## **SERVICE BULLETIN: JSB 040-2**

**Subject: Jabiru Mechanical Fuel Pump**

**Affected Models: All engines up to S/No. 22A3811 & 33A2768.**

**Figure 1 Mechanical Fuel Pump Brass Inlet Hose Tail location**

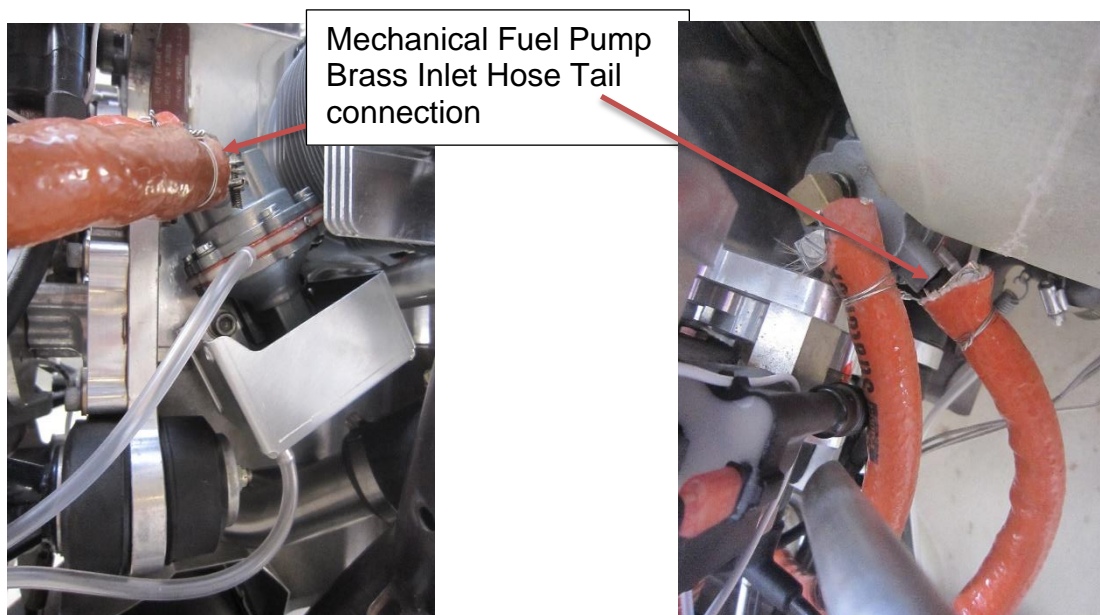
- 1) Remove the aircraft cowl.
- 2) Locate the mechanical fuel pump (the position on engine is shown in Figure 1).
- 3) Inspect the brass fuel inlet hose tail to fuel pump body connection for security of attachment.

**Figure 2 Mechanical Fuel Pump**

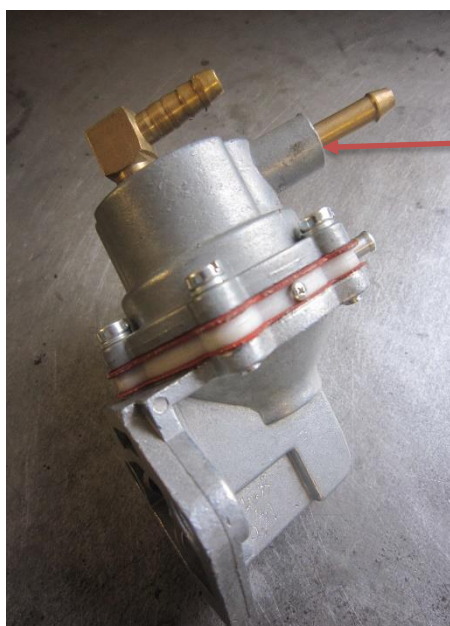
Inspect the security of the fuel brass inlet hose tail in the body of the fuel pump

If it is found that the hose tail is loose in the body of the fuel pump, this condition must be corrected **before further flight**. Contact Jabiru Aircraft if this situation is encountered and complete a Continued Operating Safety Reporting Form that can be found at the following web address: [http://jabiru.net.au/images/Owner\\_Operator\\_Responsibilities.pdf](http://jabiru.net.au/images/Owner_Operator_Responsibilities.pdf)
